Bronxx Pty Limited

Ref: 30N-22-0165-TNT-67874-4

277 The Grand Parade, Ramsgate Beach, NSW

**Wind Impact Assessment**

Figure 1: Comparison of the Ground floor plans (Top - updated Sep 2024; Bottom - Design assessed in July 2022)

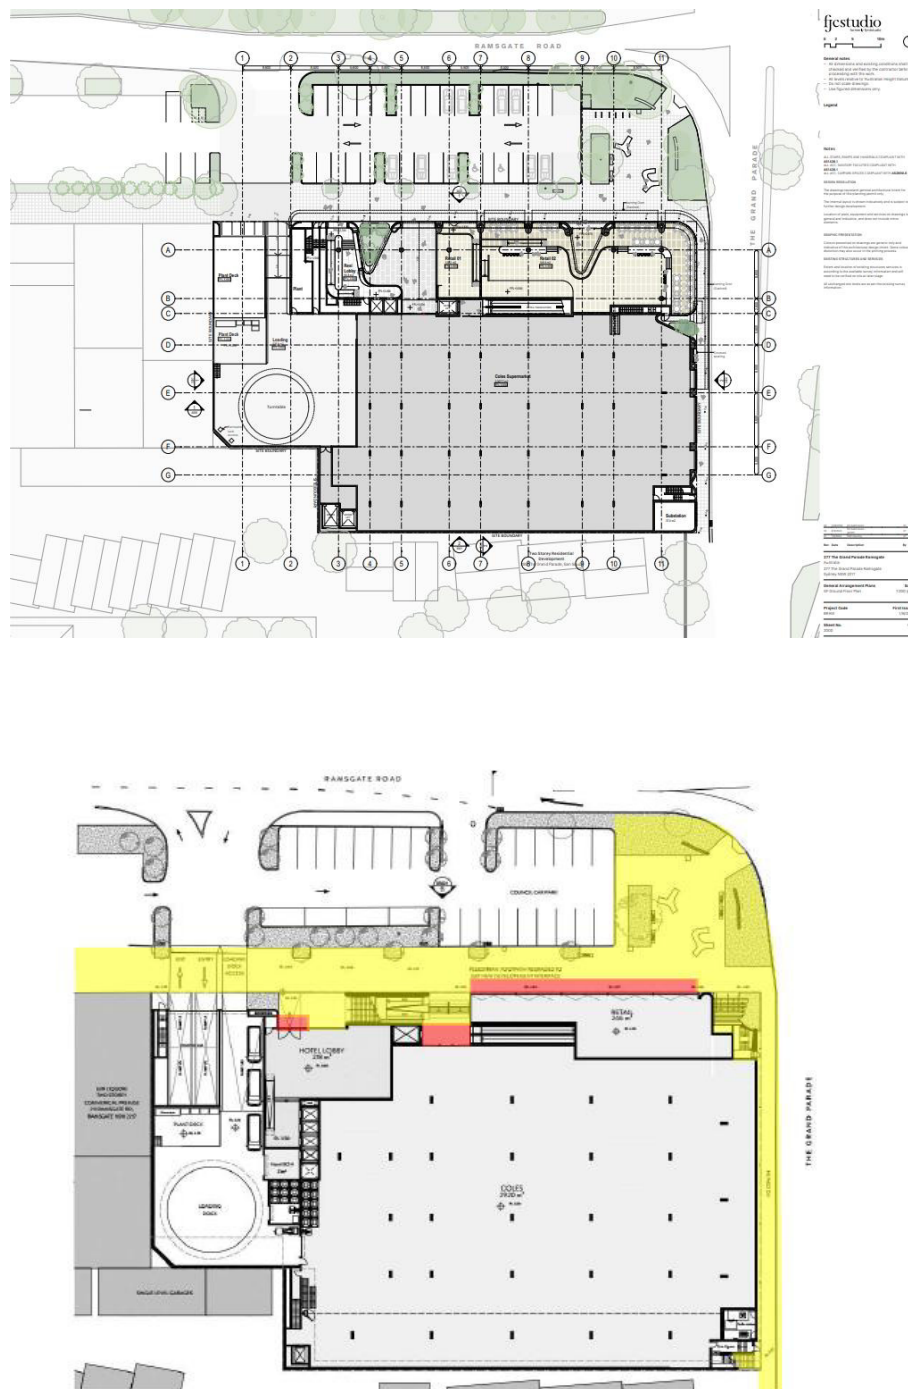
- ii) The ground floor plan has been revised with lobby entry and retail 01 entrance at the north boundary. There is a proposed canopy over these entrances (Figure 1). The entrance to retail 02 has a setback design with a sliding door. The supermarket entry is well setback under the building massing. Front of these entrances are expected to have an acceptable wind environment.

In conclusion, the Sep 2024 design of the proposed development would be expected to generate the similar wind environment to previous design, or even better. However, Vipac recommends wind screens to the ground level outdoor seated areas for the updated plans.

Figure 2: Comparison of the Level 1 plans (Top - updated Sep 2024; Bottom - Design assessed in July 2022)

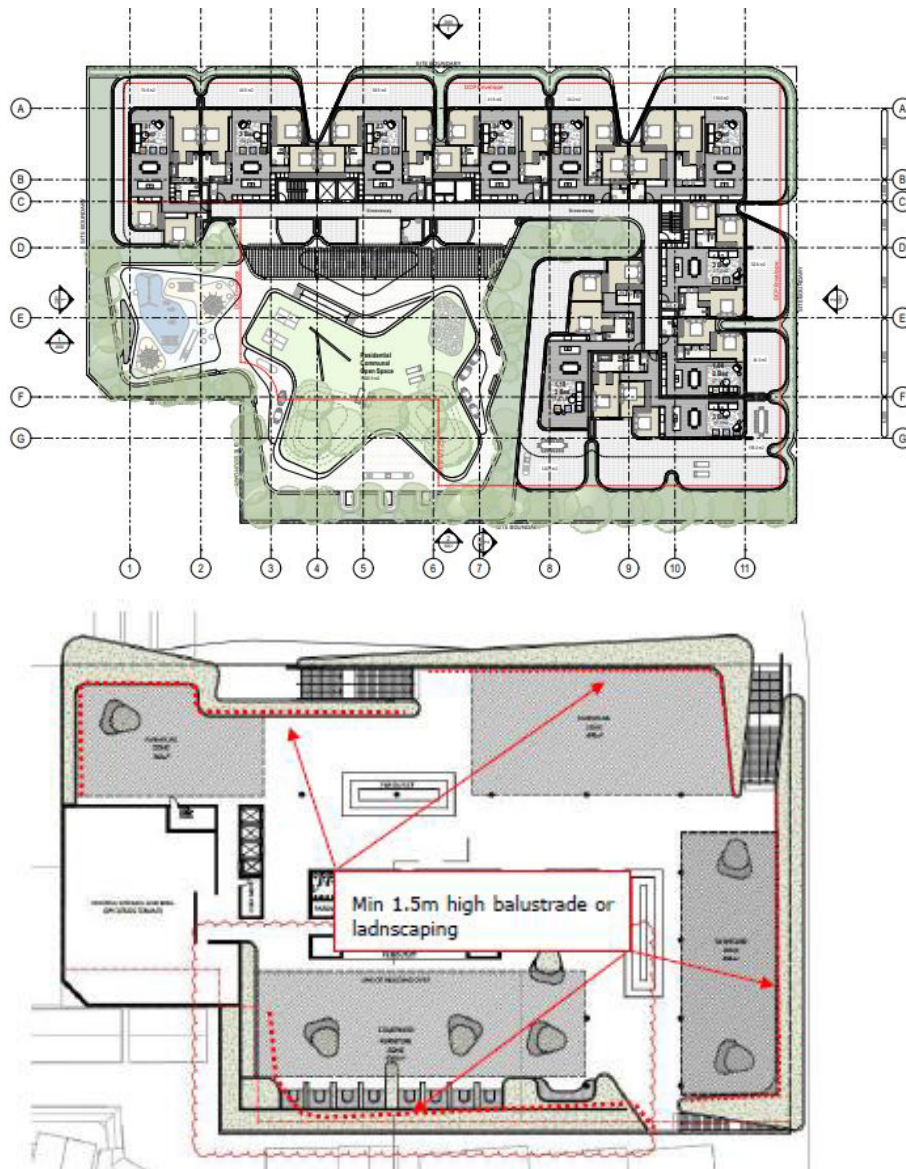
- iii) Level 1 features a residential communal open space with a number of outdoor seating areas. However, the communal open space is sheltered by the building from north and east sectors. It is expected to have acceptable wind conditions with the proposed design features and landscaping.

Figure 3: Comparison of the Level 2 plans (Top - updated Sep 2024; Bottom - Design assessed in July 2022)

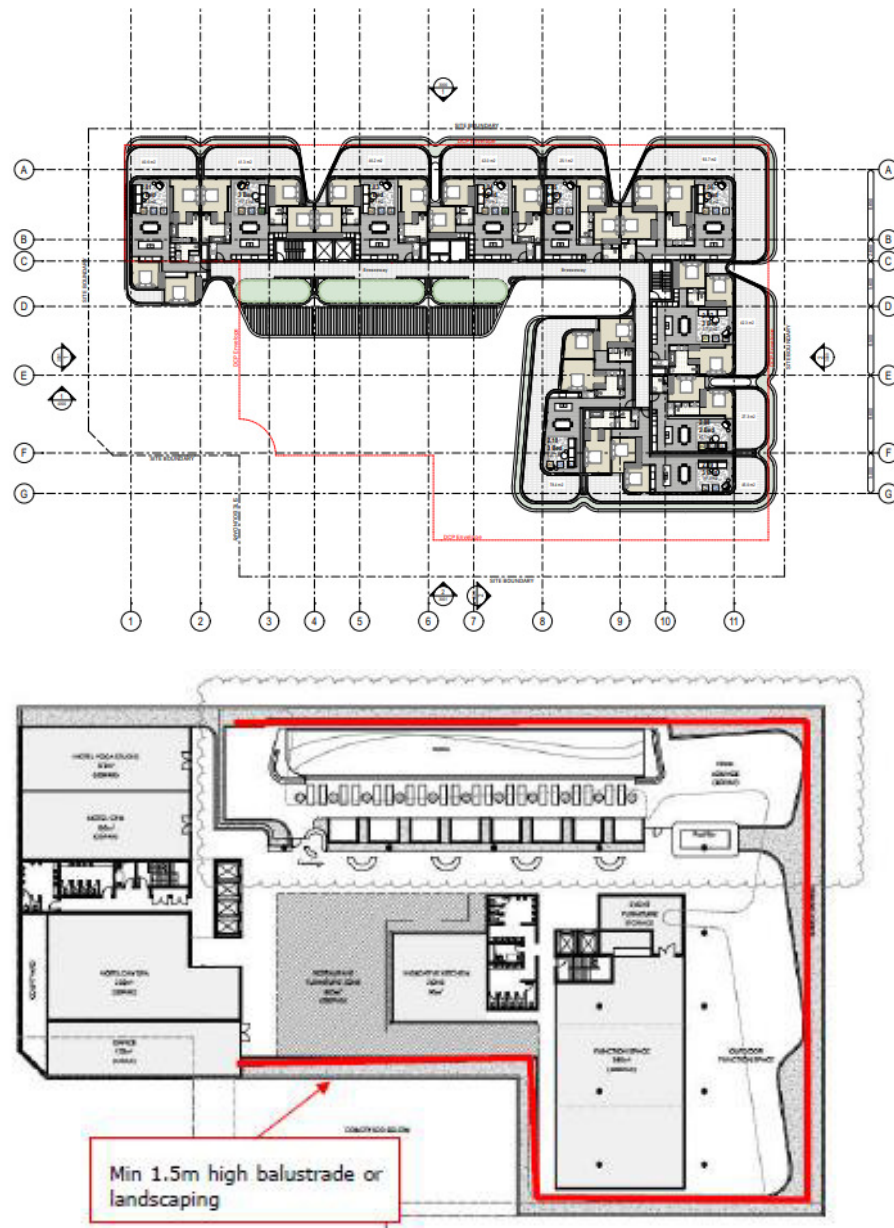
- iv) The previous recommendation for level 2 is no longer relevant due to the design changes.
- v) The rooftop terrace amenity areas have been removed; as such previous wind control measures for the roof terrace are no longer relevant.

Figure 4: Comparison of typical (Level 3) plans (Top - updated Sep 2024; Bottom - Design assessed in July 2022)

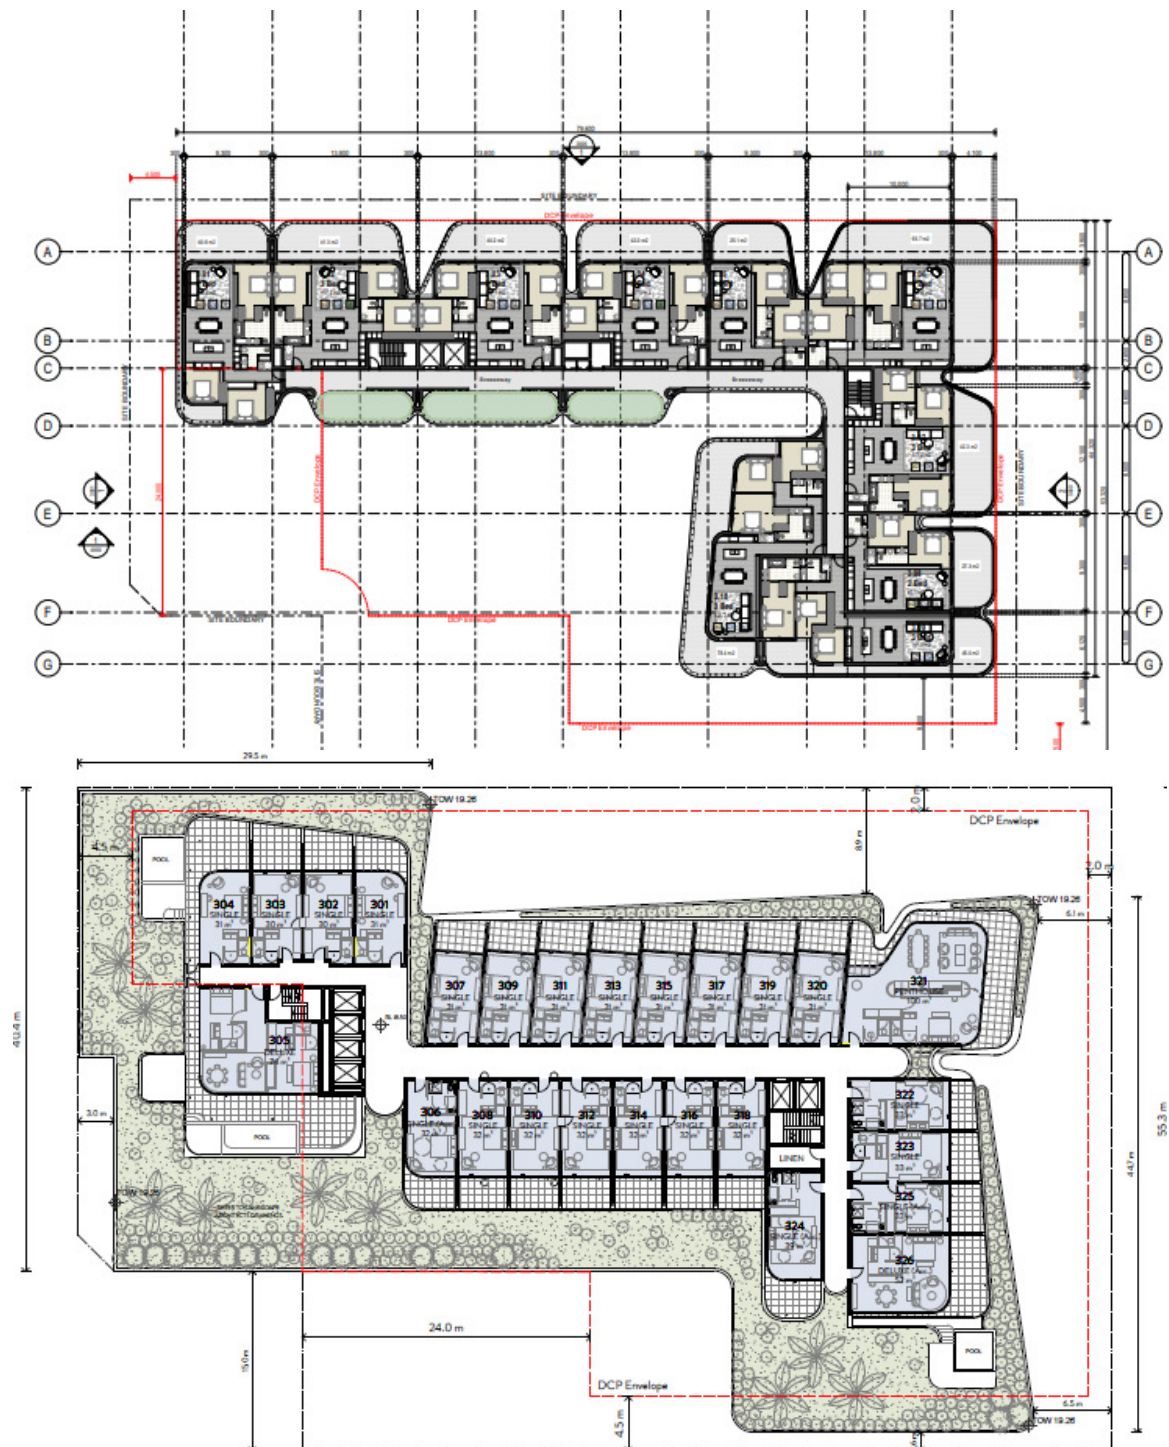
- i) The floor plans and arrangements are largely similar in shape and form (Figure 1 to Figure 5); however, the tower has shifted further towards the eastern and northern boundaries such that the tower is now setback 1-2m from the northern and eastern boundaries; This is generally expected to increase corner accelerating winds at the ground level. Given the height of the proposed development, wind levels are not expected to be in excess of the recommended walking comfort criteria.

Figure 12: Level 1 plan with the recommended wind control measures overlaid

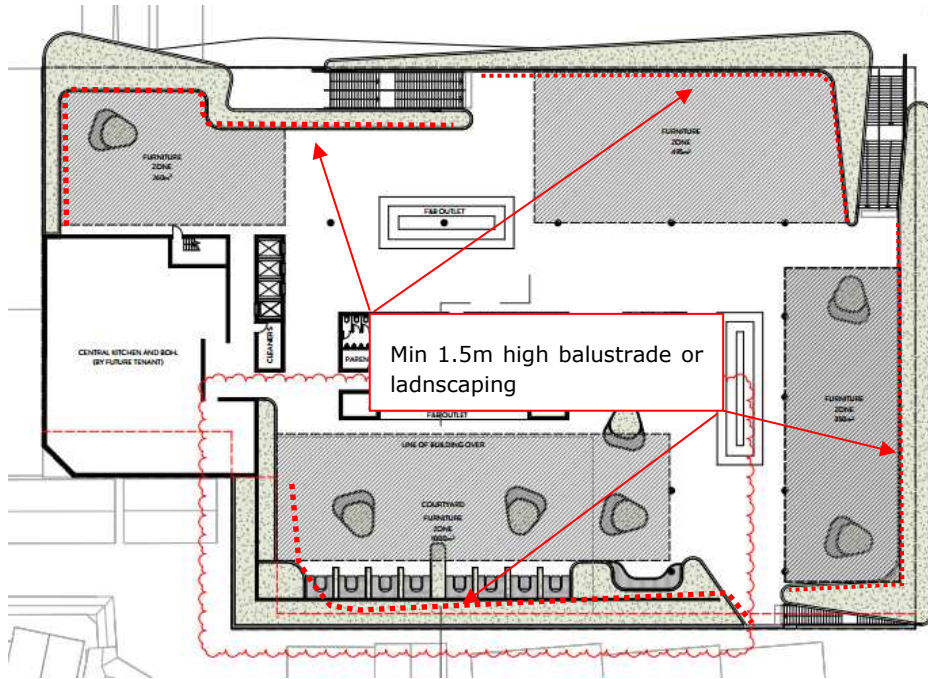
Plaza spaces are proposed at the level 1 which feature food and beverage outlets and dining spaces in north, east and south. Most of these spaces are recommended sitting wind environment. It is recommended that, as a minimum, 1.5 m high windscreens at the outer perimeter of the seated areas are required (Figure 12). Or as an alternative, the proposed landscaping along the marked locations, should be in the similar height. This could be a 1m high fixed planter with 0.5m high vegetation. More wind control measures like localized wind breaks might be needed which could be determine via a wind tunnel test.

Figure 13: Level 2 plan with the recommended wind control measures overlaid

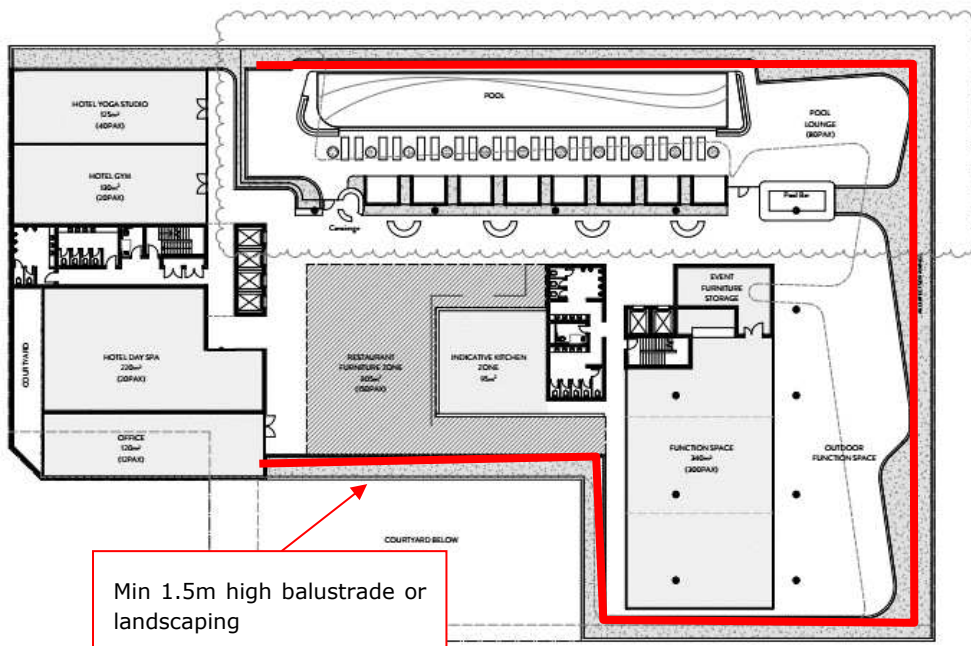
Similar to Level 1, the outdoor dining space, function space and pool and pool deck are proposed at level 2. Most of these spaces are recommended standing or sitting wind environment. We recommended that, as a minimum, 1.5 m high windscreens at the outer perimeter of these areas are necessary (Figure 13). Or as an alternative, the proposed landscaping along the marked locations, should be in the similar height. This could be a 1m high fixed planter with 0.5m high vegetation. More wind control measures like localized wind breaks might be needed which could be determine via a wind tunnel test.

Figure 15: Roof plan with the recommended wind control measures overlaid

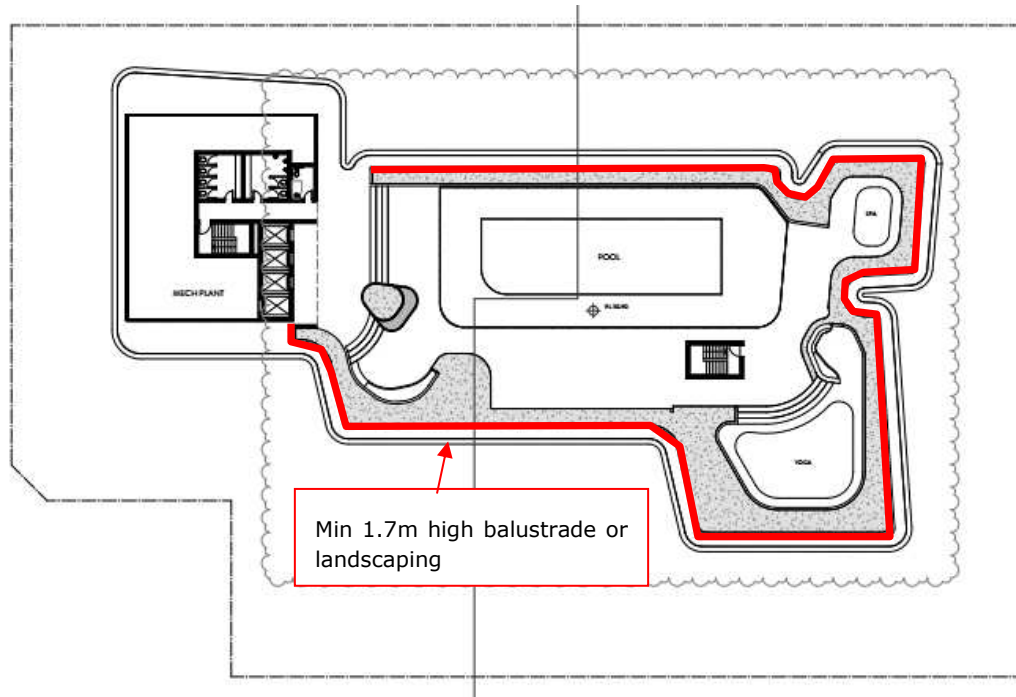
The rooftop garden might experience high wind conditions due to the height and exposures. We recommended that, as a minimum, 1.7 m high windscreens/balustrade at the outer perimeter of the garden are necessary or the proposed landscaping should have a similar height (Figure 15). More wind control measures might be needed which could be determine via a wind tunnel test.
